***Delegated Decisions by Cabinet Member for  
Environment (including Transport)***

***Thursday, 11 January 2018 at 10.00 am  
Committee Rooms 1&2 - County Hall, New Road, Oxford OX1  
1ND***

## **CABINET MEMBER FOR ENVIRONMENT – 11 JANUARY 2018**

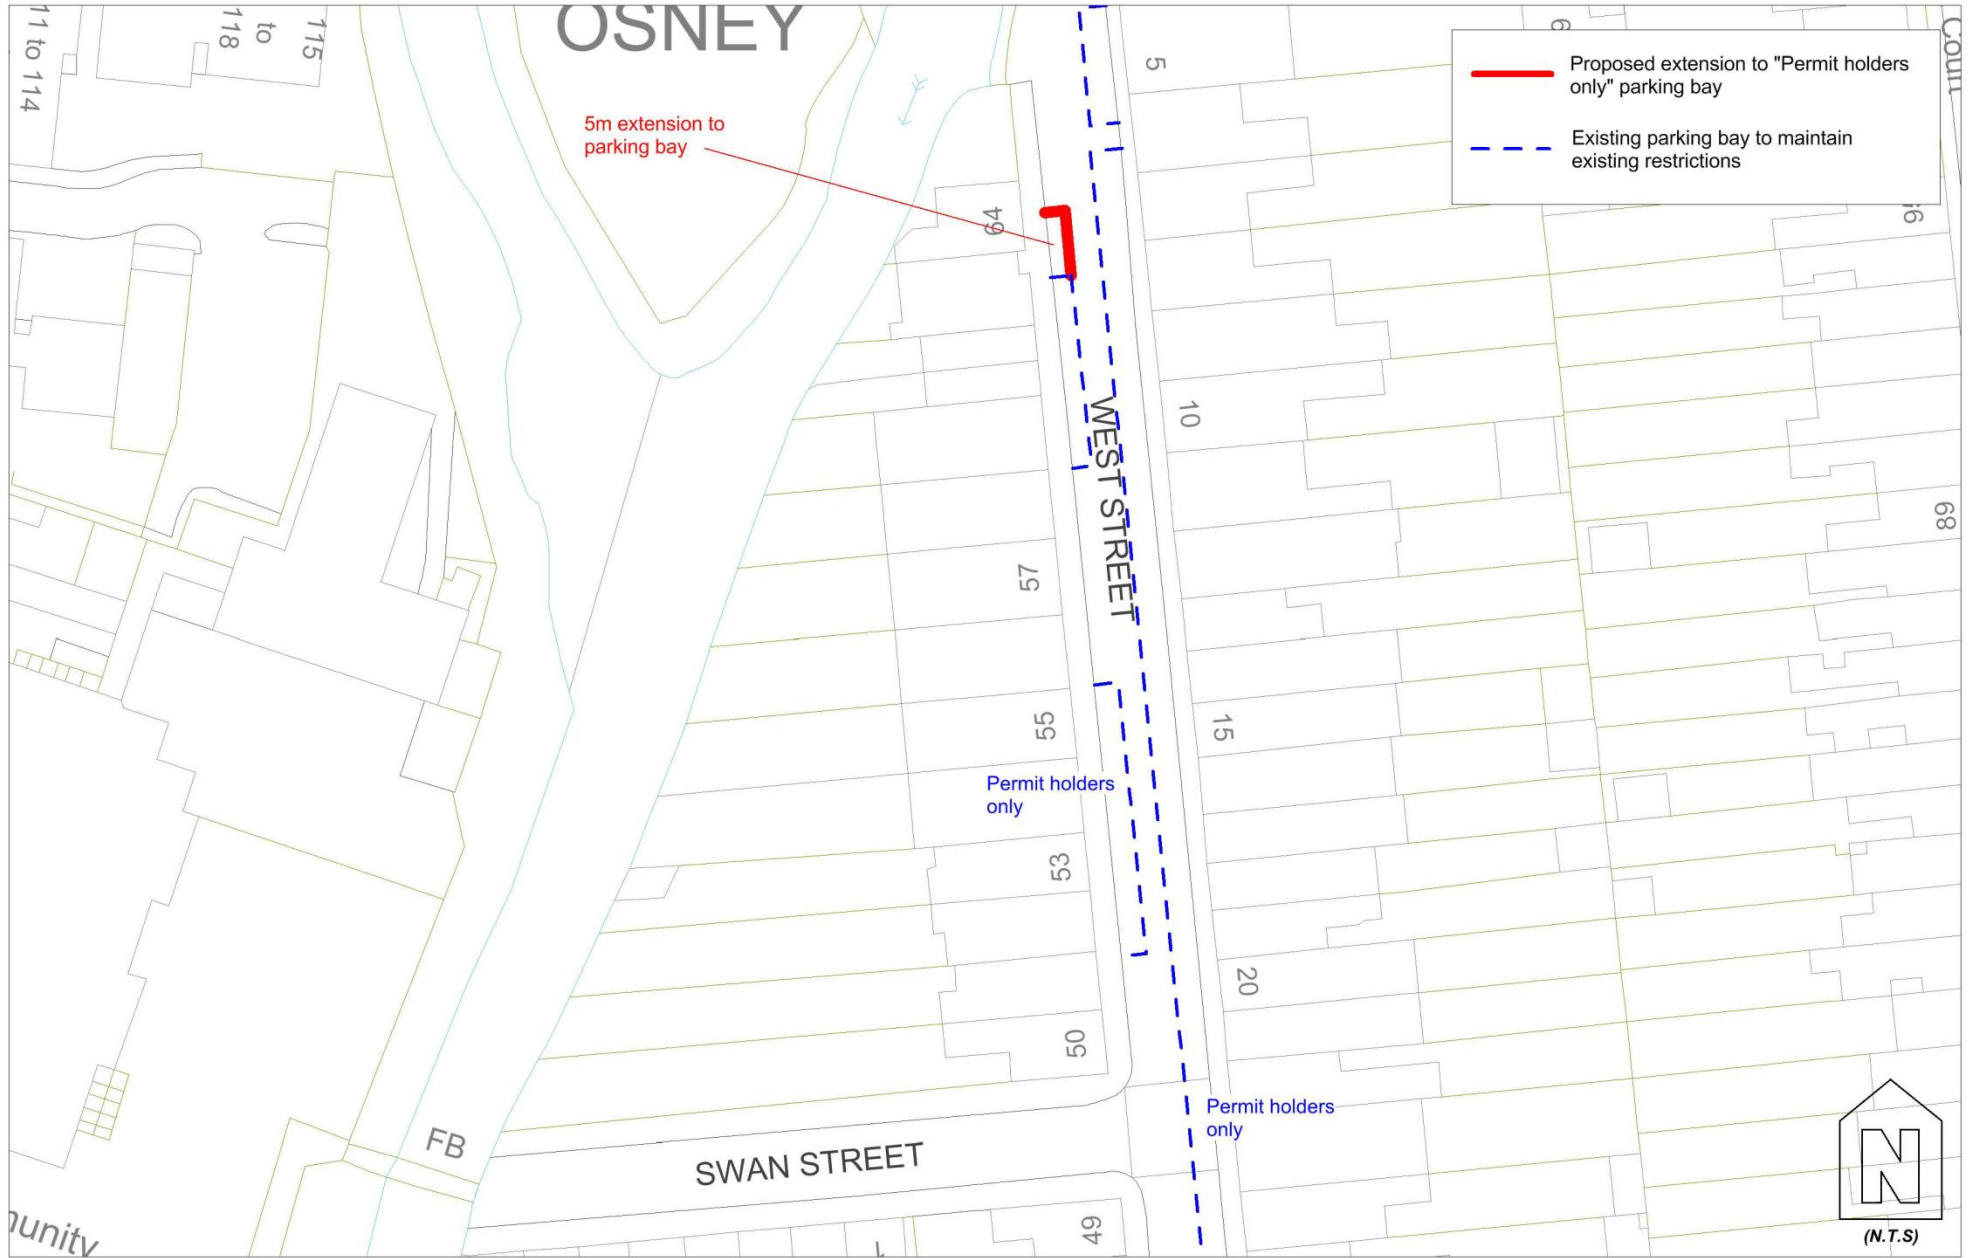
(3) Local Resident, (Oatlands Road, Oxford)	<b>Object</b> - Why is a new parking spot required? Can't the shared vehicle replace one of the existing spots? This is not clear in the documents. West street in close to the centre of the city and car parking should be discouraged. A car share should remove vehicles from the road, not to add more! The area where this spot is proposed is useful to pull over and allow oncoming vehicles to pass. Without this spot free, drivers would be required to reverse around a bend. The pavement ends near this spot and parking here would restrict visibility of pedestrians to drivers as they cross the roadway. This area is used for the Osney Flood defences and should they may restrict the rapid deployment of the barrier if a car is parked in this spot.

(4) Local Resident, (West Street, Oxford)	<b>Object</b> - The proposed new resident parking space is a good idea but it is going to cause problems. The street bends just after this new space is suggested. The way we have it now allows for one car to park there temporarily, either the one going into West street or the one driving out of it, and wait for the other car coming the other way to pass. I have often been in that situation, and when the vehicle coming the other way is a Tesco delivery van, if it wasn't for that space suggested to be the new resident parking space, we would be completely stuck, one vehicle would have to back up, not easy to do at all on that bend. I suspect there is a reason for the street parking to stop where it stops now, whoever drew this the last time knew exactly the situation. I am very concerned that if we have a new resident parking space there we will congestion at the North end of West street, for cars and vans, and bicycles too! lets not forget the pavement is almost inexistent there! Surely a charger can be installed by the next parking space already in existence?

7. While it is accepted that the proposed extended parking bay will – when occupied by a parked car - be closer to the bend, it is considered that there is still sufficient space for this not to present a significant issue for road users, although the operation of the new layout – should it be approved – will be monitored to confirm this is the case.
8. In respect of the query why the charging point equipment could not be installed adjacent to the existing bay, there are site constraints that would make this inconvenient for the adjacent premises.
9. The fixing point for the removable flood defence barrier is at the north end of the proposed extended bay and so the latter should not impact in any way on the deployment of the barrier.

**Drawing title**  
LOCATION PLAN  
SOUTH PARADE TO  
MORETON ROAD  
RAISED SIDE JUNCTIONS

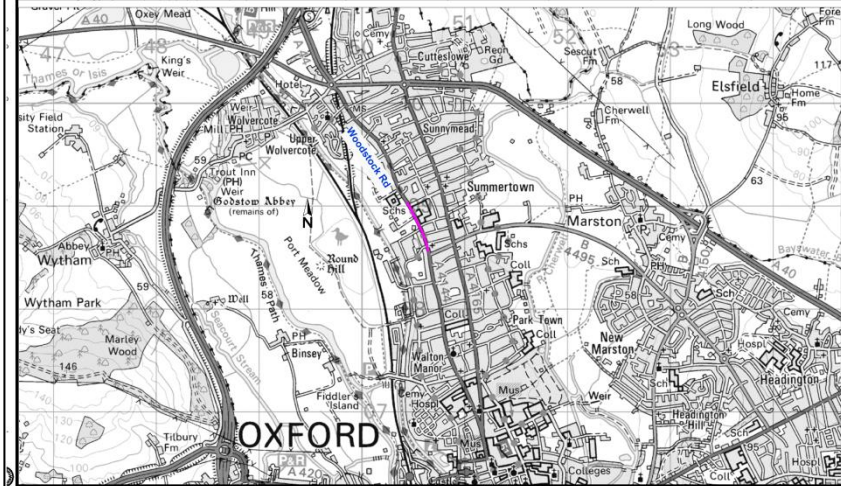
RESPONDENT	SUMMARISED COMMENTS
(1) Traffic Management Officer, (Thames Valley Polcie)	<b>No objection.</b>
(2) Cyclox	<b>Support</b> - We support the concept of doing a raised side entry treatment, but with reservations, including the need to tighten the layout the of the South Parade junction, and to increase the height of the treatments to 100mm (rather than the 75mm as proposed), and subject to the detail of the road markings. A considerable number of other improvements are desirable for the safety and amenity of cyclists on the A4144 Woodstock Road and adjacent side roads (see accompanying email).

(3) Local Resident, (York Avenue, Oxford)	<b>Object</b> - This area of north Oxford does not have a traffic speed problem due to the appalling lack of highway surface maintenance. The potholes in this area are a disgrace to the city. Introduction of the proposed humps will only increase air borne pollution for the pedestrians in the area without contributing to pedestrian safety. The County Council budget cannot find the budget to maintaining the existing humps the council have installed throughout the county without increasing the number for no good reason.

(4) Online response, (unknown)	<b>Object</b> - While I see the point of placing a hump in the road to slow down cars turning off faster roads into residential side roads, I totally fail to see how a hump at the junction of South Parade with Woodstock Road would improve road safety.  Traffic is already obliged to stop at the end of South Parade, which is a one-way street, before turning to join the Woodstock Road.

<p>(7) Online response, (unknown)</p>	<p><b>Object</b> - Elsewhere (Cowley for example) flat top humps are damaging vehicles due to being overly steep.</p>
<p>(8) Local Resident, (Park Close, Oxford)</p>	<p><b>Object</b> – 1: I would like to see the Budget for this proposal, 2: In principle, speed humps have been shown to have minimal value. Cars slow down for them but accelerate afterwards increasing pollution. They can damage vehicles and can be a problem for the emergency services, 3: Specifically, these proposals are a waste of time at the ends of the roads as vehicles have to slow down to Give Way to traffic on the Main Road. They are already very congested and naturally slow the traffic down.</p>
<p>(9) Member of the public</p>	<p><b>No Objection</b> – but raises queries in respect of the camber of the carriageway, which has increased over time and helps to make vehicles, especially tall ones, presents a greater threat to cycling in the bus lane. Also would like to view proposed road markings - reproducing what is currently in place will not be appropriate. At the South Parade junction, it would be better to narrow the exit to one lane with a more right angle turn to benefit both pedestrians crossing here and improve the view for drivers turning onto the Woodstock Road of cyclists in the bus lane. As a wider comment, it would be logical to enable two-way cycling on these one way streets.</p>

8. The response of Thames Valley Police expressing no objection is noted.
9. Cyclox's response and that of the member of the public expressing very similar views are similarly noted. It is proposed to amend the southern kerblines of South Parade slightly, albeit not to the extent that appears to be requested in these responses, with the two lane approach to the junction being maintained, noting that this junction does have a good safety record. The only reported accident here in the latest five years involved a vehicle turning into South Parade failing to comply with the no entry sign and therefore not considered relevant to the issues being raised in these responses. The specification of the raised treatment in respect of its height (75mm) is as widely used in other similar treatments, with the proposed road markings also following established practice. The County Council shares the aspirations expressed by Cyclox to significantly improve the safety and amenity of cyclists, including on the A4144 Woodstock Road and adjacent streets, but it is considered that the suggestions made in this respect fall outside the scope of this maintenance scheme, excepting the comment on the camber of the road, which will be reviewed.

10. In respect of the objections from the members of the public, it should be emphasised that the treatment is primarily for the benefit of pedestrians crossing the side roads, rather than the control of speeds further along the side roads. Such treatments – which have been in place for many years at other side road junctions on the Woodstock Road and also many other locations in the city – have been found to be helpful for pedestrians as a result of their reducing the speed of turning traffic at the junction and also by maintaining a level surface. The proposed specification of the treatments in respect of their height and ramp gradients should avoid any risk of damage to vehicles. The cost of providing the treatments as part of the planned major maintenance scheme is very significantly lower than would be the case if constructed as an independent project.

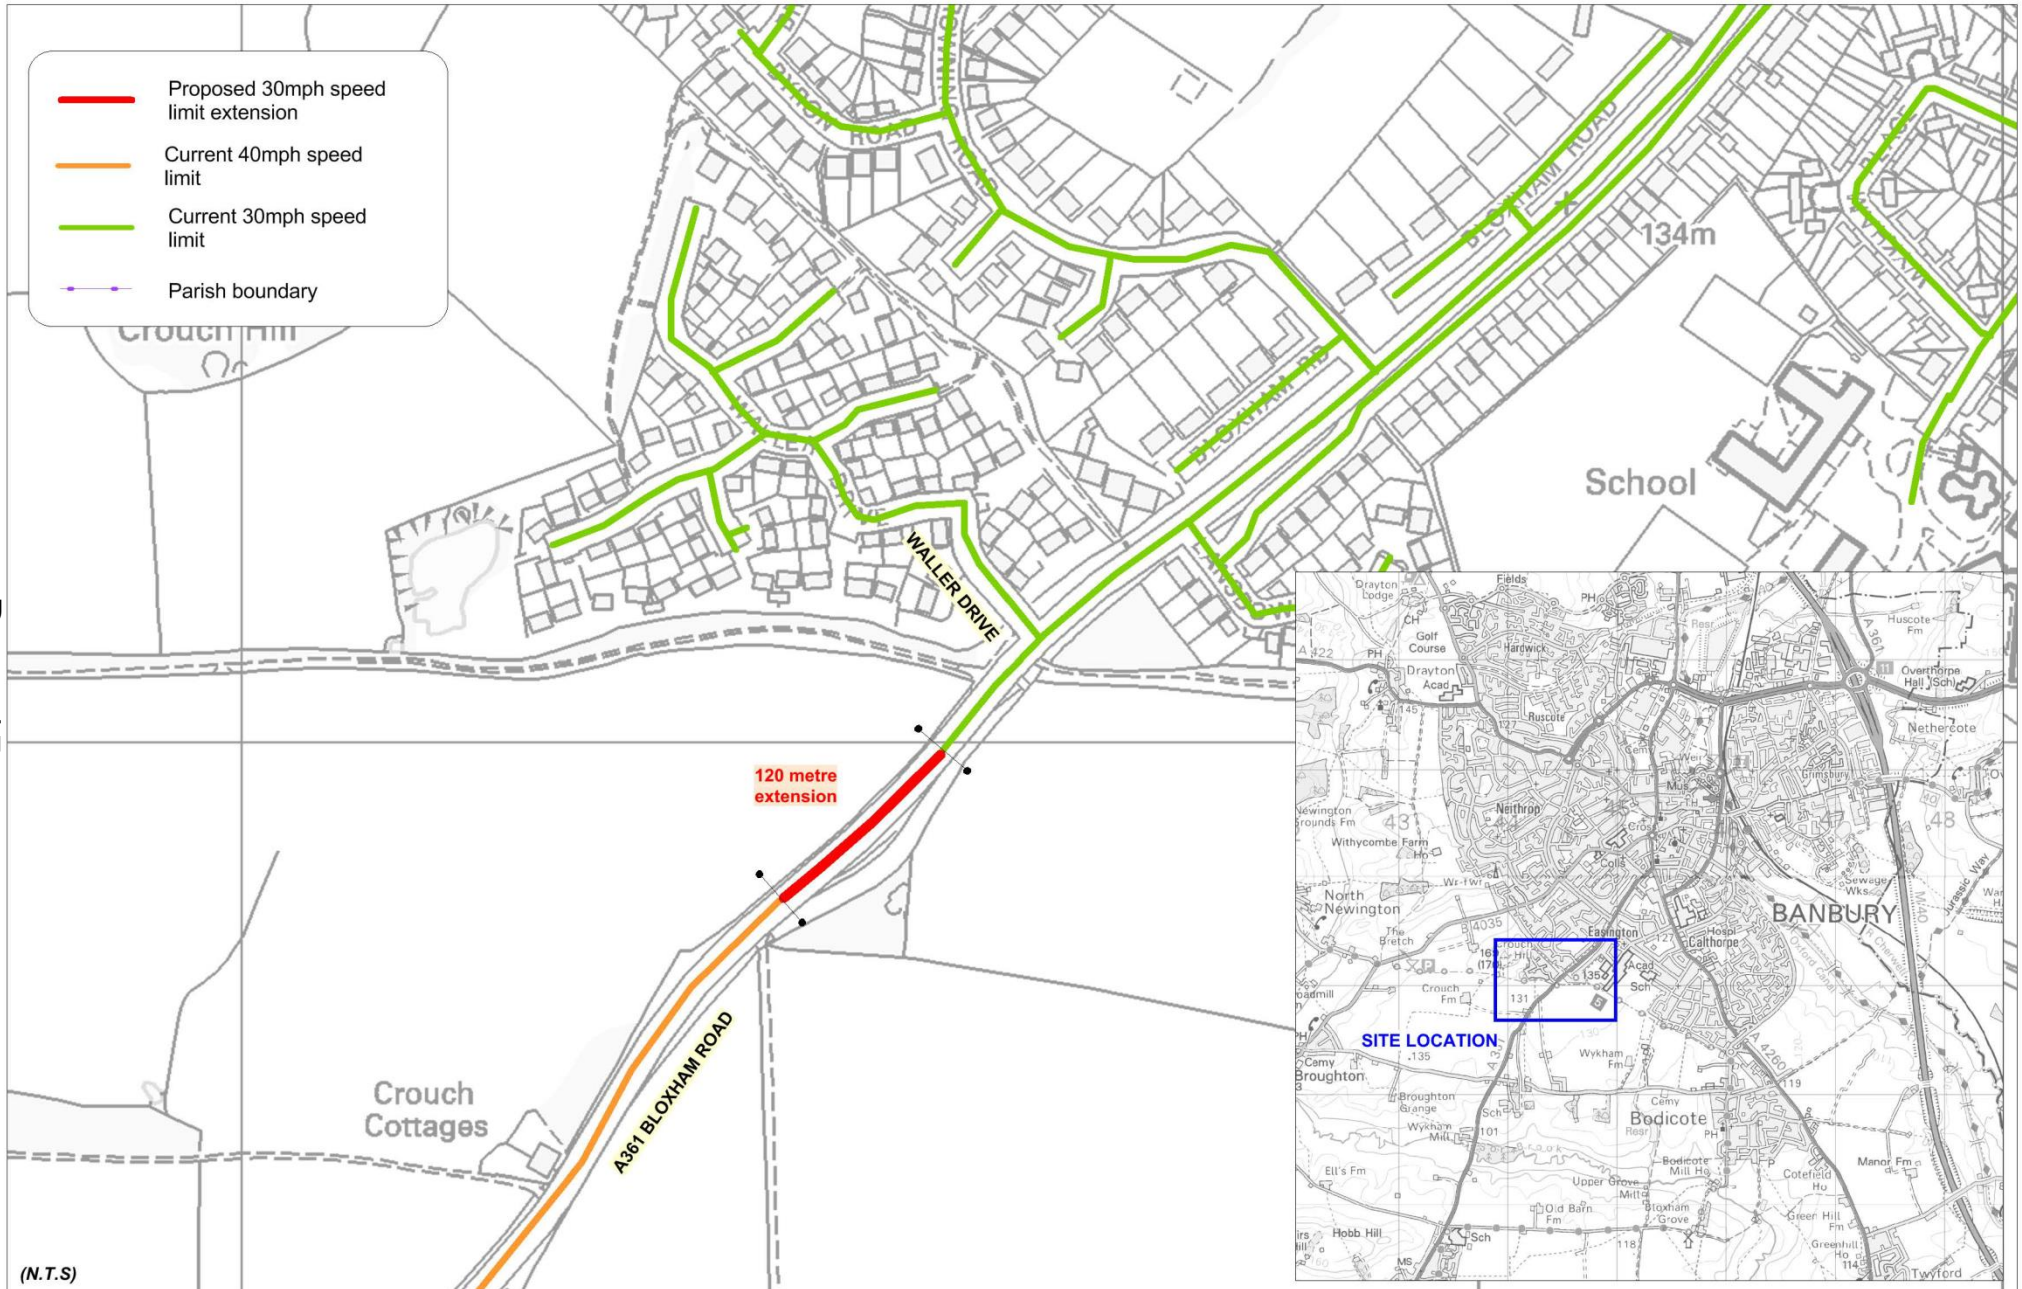
RESPONDENT	SUMMARISED COMMENTS
(1) Traffic Management Officer, (Thames Valley Police)	<b>No objection</b> - Thames Valley Police have no objections.
(2) County Councillor Kieron Mallon, (Bloxham & Easington Division)	<b>Object</b> - I alongside everybody else was not informed or consulted before the physical works were implemented! Only now after the full works have been installed are we being consulted.  I am therefore objecting to the implementation of this 30mph because of the lack of due process.

5. The objection from Cllr Mallon was on process grounds, as the signing of the extended speed limit had been put in place prior to the above consultation on the amendment to the speed limit order. It is fully accepted that the consultation should have been carried out ahead of the relocation of the speed limit signs and better liaison will be carried out within the relevant teams within the County Council to reduce the risk of similar issues arising. It should be noted that the provision of street lighting as part of the wider works in connection with the construction of the new roundabout introduced (by virtue of the street lighting) a 30mph speed limit, and in this respect the

amendment to the speed limit order does not affect the legality of the limit as currently signed.

Drawing title  
**A4130  
 Traffic Regulation Order  
 Extension of 40mph Zone**

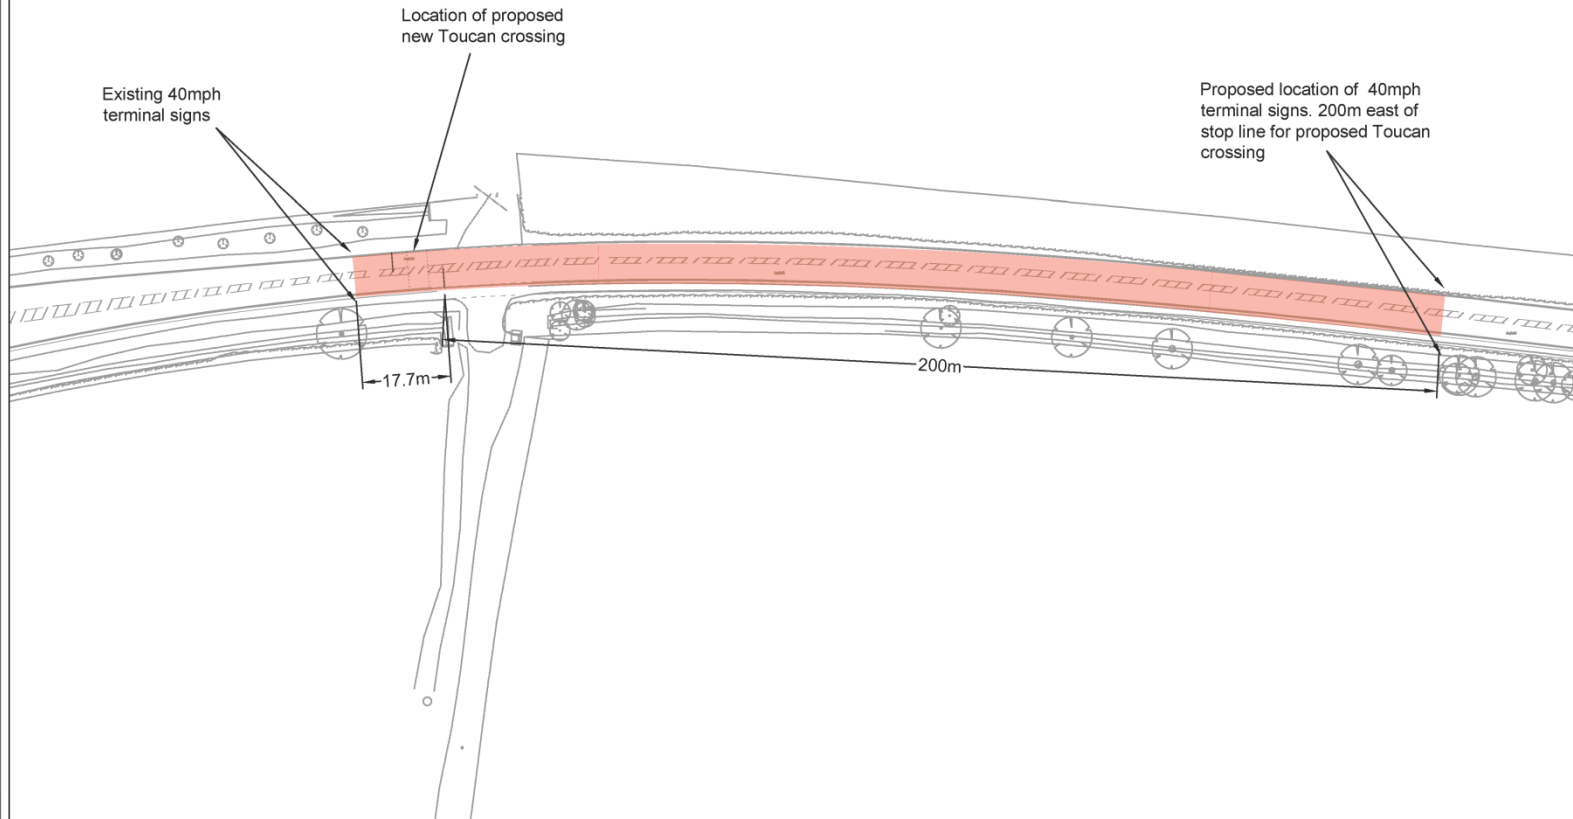
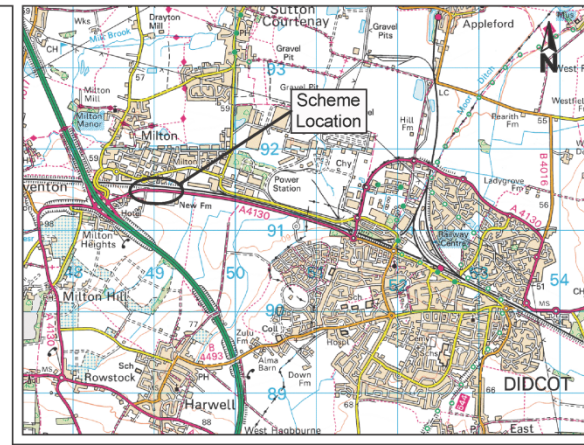
RESPONDENT	SUMMARISED COMMENTS
(1) Milton Parish Council	<b>No objection</b> – <i>No comment.</i>
(2) Didcot Town Council	<b>No objection</b> - Welcomes the prospect of increased pedestrian access to Milton Park. However, there are concerns over the location of the proposed crossing's proximity to existing lights and other proposed crossings and the cumulative impact these crossings will have on traffic flow. We feel that the proposal may be premature at this point in time.

(3) Traffic Management Officer (Thames Valley Police)	<b>Object</b> - After careful consideration of the documents and speed data provided, I object to these proposals. Existing speeds are clearly too high and this could compromise safety on the crossing point. Extending the current 40mph speed limit by 200m I also feel is excessive without other measures to slow speeds.

5. The objection of Thames Valley Police is noted. A speed survey carried out in the vicinity of the crossing shows average speeds to be 45mph eastbound and 46mph westbound and it is anticipated that with the proposed 40mph speed limit in place, speeds would reduce by approximately 3mph, bringing the speeds here to a level consistent with those observed in other 40mph speed limits. It is also considered that the proposed speed limit is consistent with the Department for Transport guidance on setting local speed limits taking account of the character of the road. It should also be noted that signalled crossings of this type installed on roads subject to a 40mph speed limit operate with very good levels of safety.

6. Didcot Town Council's comment on the proximity of the proposed crossing to the traffic signalled junction to the west is noted. While it is accepted that the crossing is quite close (approximately 230 metres) to the latter junction, the separation is nevertheless considered acceptable, noting also that an independent safety audit of the crossing will be carried out. In respect of their comment that the project is premature, the crossing is being provided as part of a wider project to provide a safe route for pedestrians and cyclists to Milton Park, including the recently opened Backhill Tunnel cycle and pedestrian link .
